**DEVELOPMENT REVIEW BOARD MEETING
APRIL 12, 2021
6:30 PM**

- A. Resolution No. 388. Canyon Creek 8-Lot Subdivision: Scott Miller, SAMM-Miller LLC – Applicant for William Z. Spring and Fallbrook, LLC – Owners.** The applicant is requesting approval of a Comprehensive Plan Map Amendment from Residential 0-1 Dwelling Units per Acre to Residential 4-5 Dwelling Units per Acre, a Zone Map Amendment from Residential Agriculture-Holding (RA-H) to Planned Development Residential 3 (PDR-3) and adopting findings and conditions approving a Stage I Master Plan, Stage II Final Plan, Site Design Review, Type C Tree Plan, Tentative Subdivision Plat, and Waiver for an 8-lot residential subdivision located at 28700 and 28705 SW Canyon Creek Road South. The subject site is located on Tax Lot 6400 and a portion of Tax Lot 3800 of Section 13BD, Township 3 South, Range 1 West, Willamette Meridian, City of Wilsonville, Clackamas County, Oregon. Staff: Philip Bradford

**DEVELOPMENT REVIEW BOARD
RESOLUTION NO. 388**

Exhibit A1
Staff Report
Canyon Creek Phase 3 Subdivision – 8 New Residential Lots

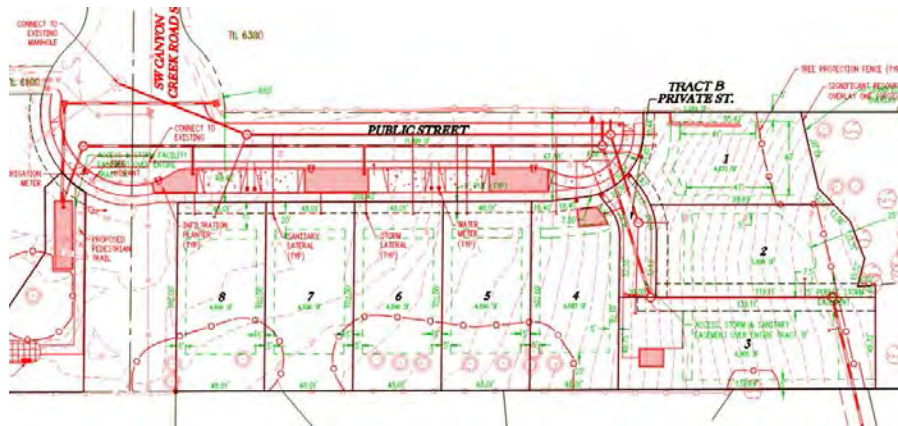
However, the arborist report notes that several of the trees shown as preserved along the rear lot lines for lots 4-8 should be reevaluated against the future home plans as the tree protection fencing overlaps with the buildable area of the proposed lots (shown in the image below delineated by green dashed lines). It is important the tree protection fencing is realistic and easy to maintain as fencing ensures construction impacts will not impact the root zones of the trees and increases the likelihood the preserved trees will survive after construction is complete. Staff has witnessed similar situations in other projects and in order to preserve the trees to the greatest extent possible, a condition of approval has been added to reassess the trees with the project arborist when the future house plans are provided to ensure maximum preservation. In the case that tree removal is requested for one of the trees indicated for preservation, the project arborist will submit a report to City Staff including a written explanation of the measures considered to preserve the trees along with the reasoning that makes preservation not feasible.

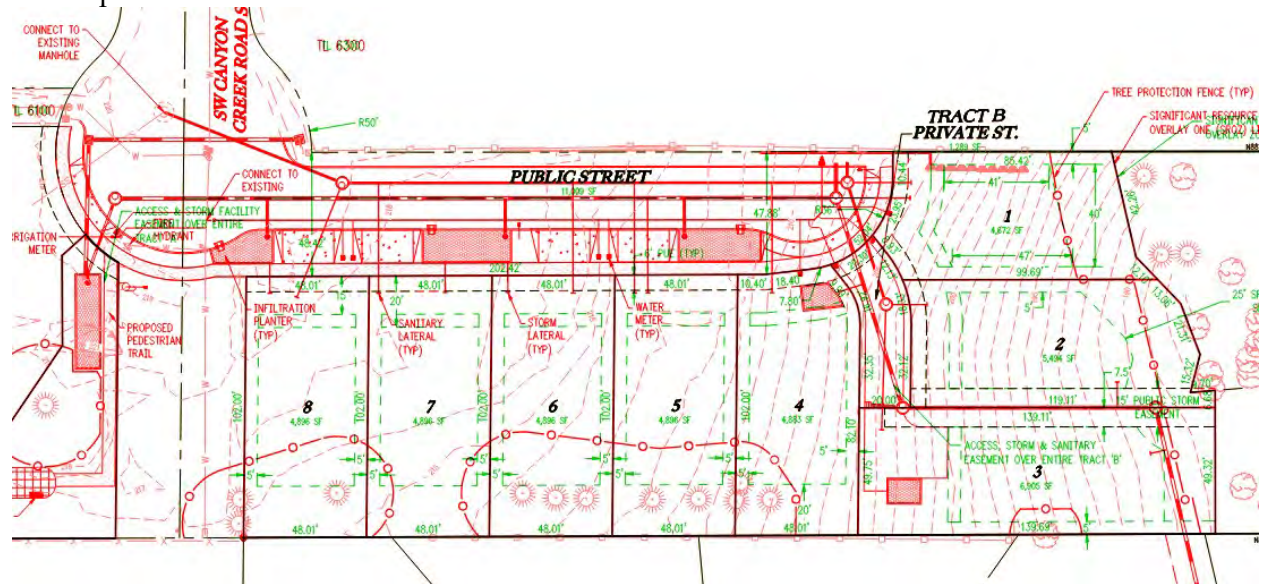
F20. The applicant proposes removal of 26 trees 6 inches d.b.h. or greater. The applicant will plant six trees as street trees and 26 trees within the SROZ, and two trees within the usable open space area exceeding a one to one ratio. The arborist report does note that 9 trees shown as being preserved on the applicant's plan set may not be feasible stating the following: *"Trees planned for retention in the rear of lots 3-6 should be re-evaluated in terms of*

future home plans. The protection zones proposed for creation of the subdivision encroach into a substantial portion of the allowable building envelopes and it may not be feasible to provide adequate protection for these trees with home building.”

Based on when the arborist report was written, the lot numbers do not reflect the current proposal and lot numbers for the final site plan. Based on the proposed plans and arborist report, staff has concerns regarding the trees proposed for retention at the rear of lots 3 – 8. The image below overlays the proposed preliminary site plan and preliminary plat and clearly shows significant overlap between the tree protection fencing and the delineated buildable area of the lots. The trees are depicted directly adjacent to the potential building envelopes.

Staff questioned the applicant on the proposed tree preservation plans as they relate to the construction of future homes on the newly created lots. The applicant’s response contained in Exhibit B5 states: *“The submitted tree preservation and removal plan is specific to the construction of the subdivision only and does not include potential tree removal to accommodate the future homes. Any necessary tree removal required for lots 4-6 and 7 to accommodate future dwellings will be addressed during the building permit review process.”*

By time of this staff report publication, the Applicant did not submit new exhibits showing modified building envelopes. Nor did the Applicant submit new findings and exhibits to modify the tree removal and protection plan as a result of a reduced buildable area that would not be feasible. As such, staff has included Condition of Approval PDF 9 that requires an assessment and written report by an arborist if any of these preserved trees are proposed for removal in the future due to construction; the report must provide a written explanation of the measures considered to preserve the trees along with the line of reasoning that prevents preservation, submitted to City staff, who will verify the validity through review by a second arborist.

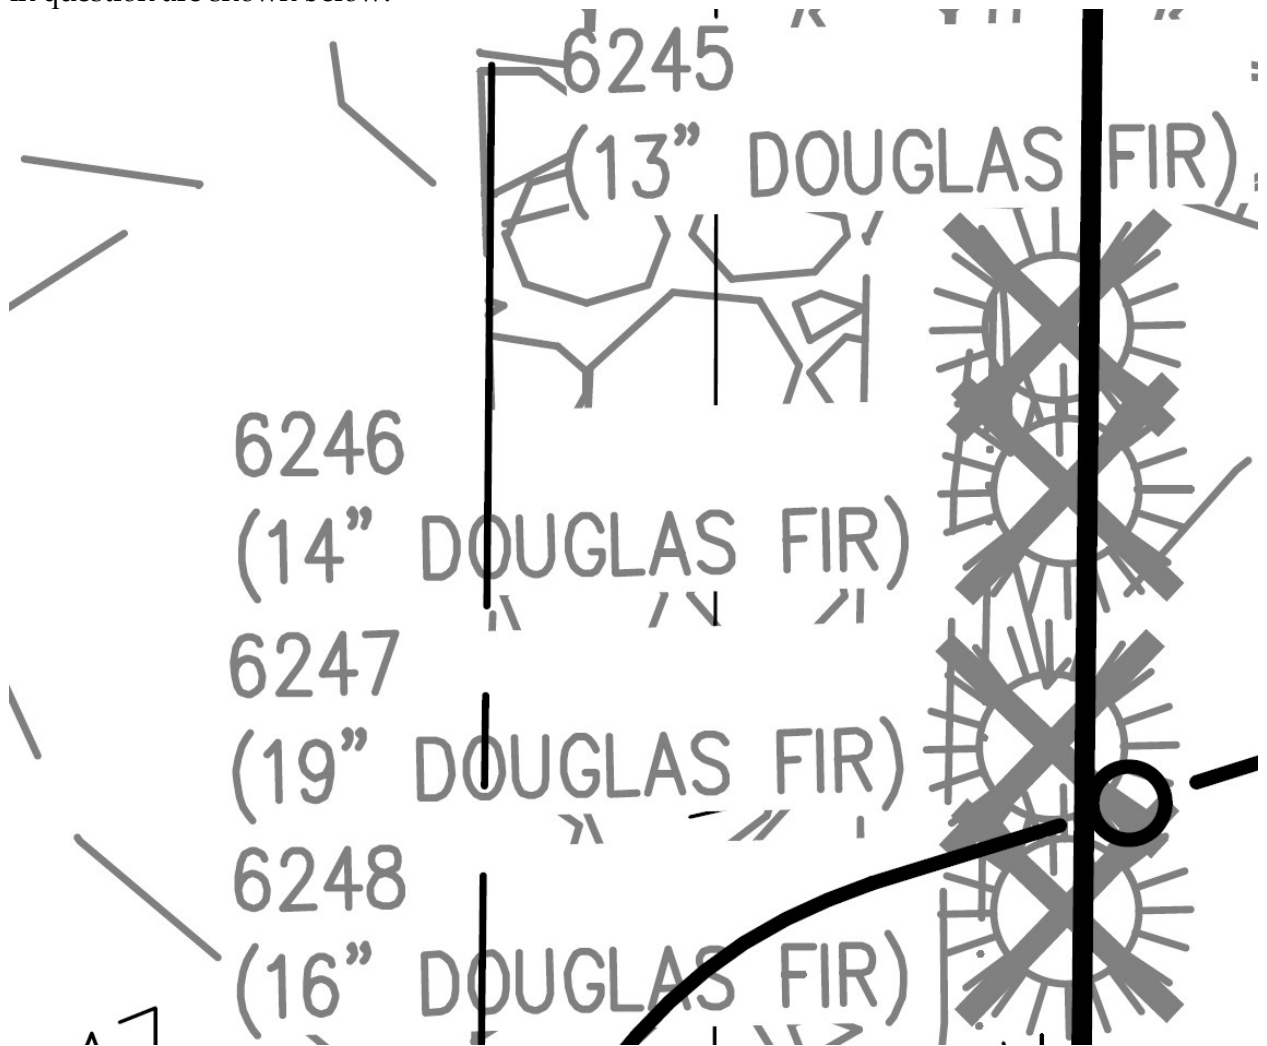
In addition to the issues concerning the trees at the rear of lots 4-8, the trees proposed for removal along the western property line of Lot 8 appear to be on City of Wilsonville property and the applicant does not have City permission to remove these trees. The trees in question are shown below:

Condition of approval PDF 8 requires Tree Numbers 6245 (13" Douglas Fir), 6246 (14" Douglas Fir), 6247 (19" Douglas Fir), and 6248 (16" Douglas Fir) shall be retained unless City approval and signature is granted for these four (4) trees. The applicant shall revise the tree protection fencing plan to ensure these trees are properly protected during grading and construction.

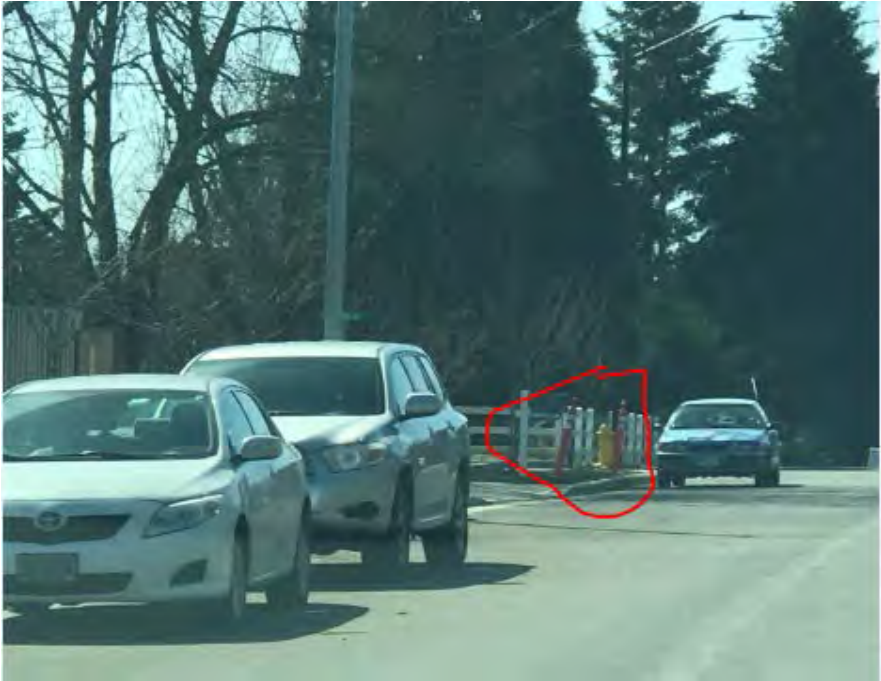
This grove of trees will be removed for a community garden for 8 homes?

Parking on street. Residents have cones circled in red to keep people from parking in front of their home.

Residents of Aspen parking in front of other residents homes on Daybreak because they can't park on their street because of not parking.

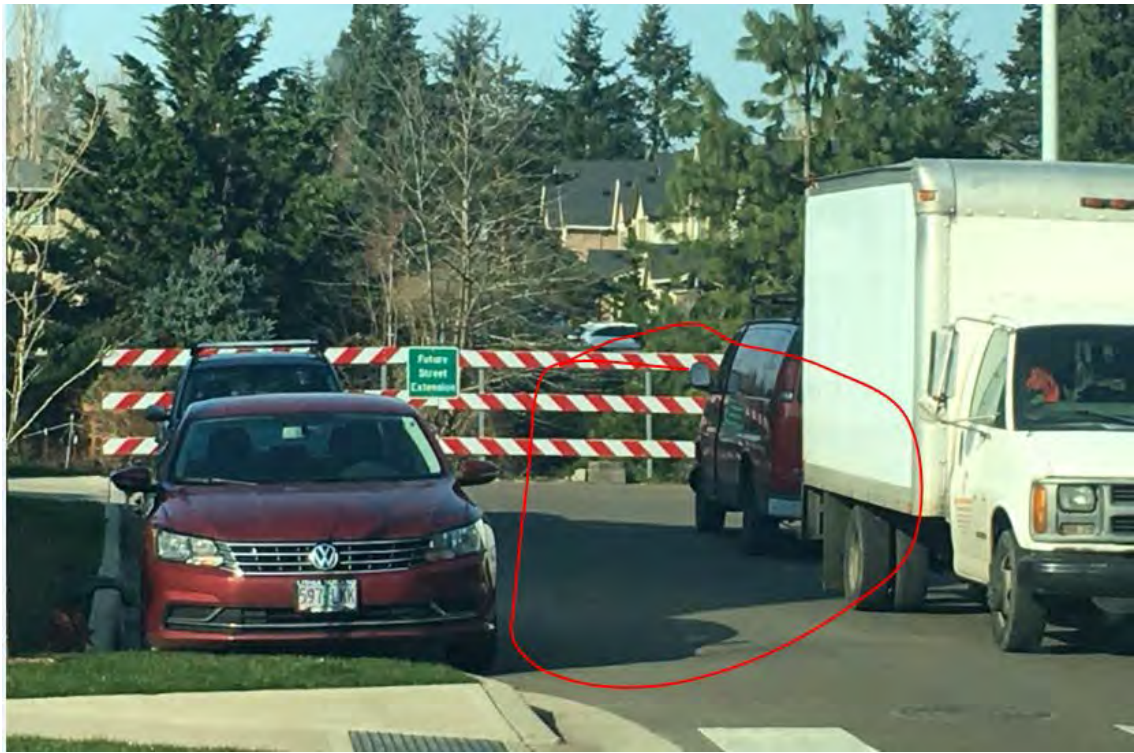
Can a fire truck or Ambulance fit through here?

This RV is parked on the sidewalk? Aspen Meadows

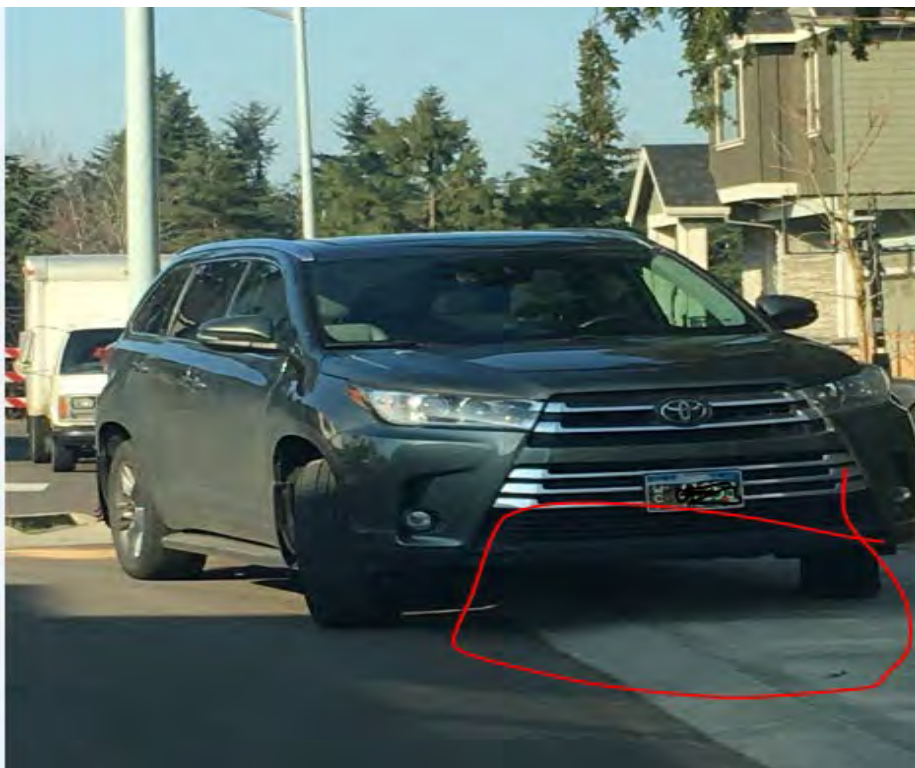
Parking on the sidewalk? Aspen Meadows

Dumping occurring for years in RSOZ zone.
